Access Compliance Report

Public Rights-of-Way

(Curb Ramps)

Intersection ID: 31688	Main Street: TRIECE_LN	Cross Street: WILLIE_WORRELL_DR	Location: NW
ADA ID: 655219D0C427	Ramp Type: Perpendicular Diagonal	Initial Pass/Fail: Fail	Overall Compliance: No
			Severity Score: 17.5

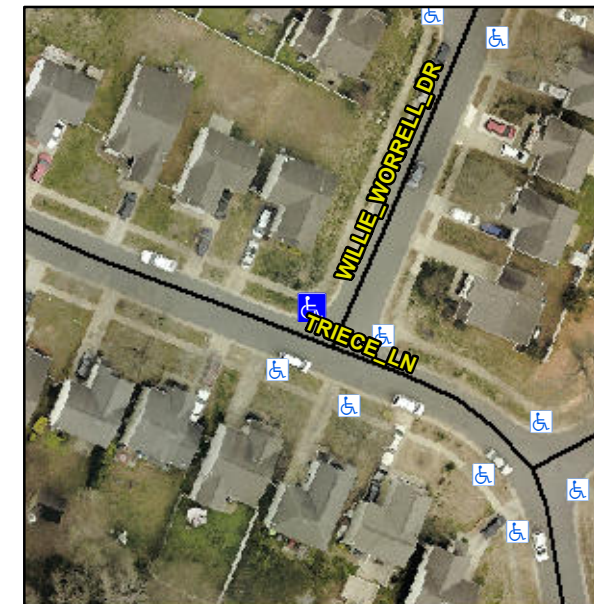
Not Found, R304.5.1

Compliance	Description	Data	Compliance	Description	Data
N/A	Ramp Length (in)	82.0	Yes	Ramp Slope (%)	7.0
No	Ramp Width (in)	35.0	Yes	Ramp XSlope (%)	0.2
N/A	Flare Type LT	N/A	N/A	Flare Type RT	N/A
N/A	Flare Slope LT (%)	N/A	N/A	Flare Slope RT (%)	N/A
N/A	Flare Traversable LT?	N/A	N/A	Flare Traversable RT?	N/A
N/A	Landing Length (in)	N/A	N/A	DWS Provided?	N/A
N/A	Landing Width (in)	N/A	N/A	DWS Contrast?	N/A
N/A	Landing Slope (%)	N/A	N/A	DWS Length (in)	N/A
N/A	Landing X Slope (%)	N/A	N/A	DWS Full Width?	N/A
N/A	Landing Curb? (Y/N)	N/A	N/A	DWS Offset (in)	N/A
N/A	Shared Landing?	N/A			
N/A	Gutter Ponding?	N/A	N/A	Gutter Slope (%)	N/A
N/A	Gutter Lip Ht (in)	N/A	N/A	Gutter X Slope (%)	N/A
N/A	Painted X Walk1?	No	N/A	Painted X Walk2?	No
	X Walk 1 Direction	To SW		X Walk 2 Direction	To SE
N/A	X Walk 1 Width (in)	N/A	N/A	X Walk 2 Width (in)	N/A
	X Walk 1 Slope (%)	3.3		X Walk 2 Slope (%)	0.9
	X Walk 1 X Slope (%)	2.0		X Walk 2 X Slope (%)	0.0

Remove & Replace Curb Ramp With Two New Directional Ramps or Equivalent.
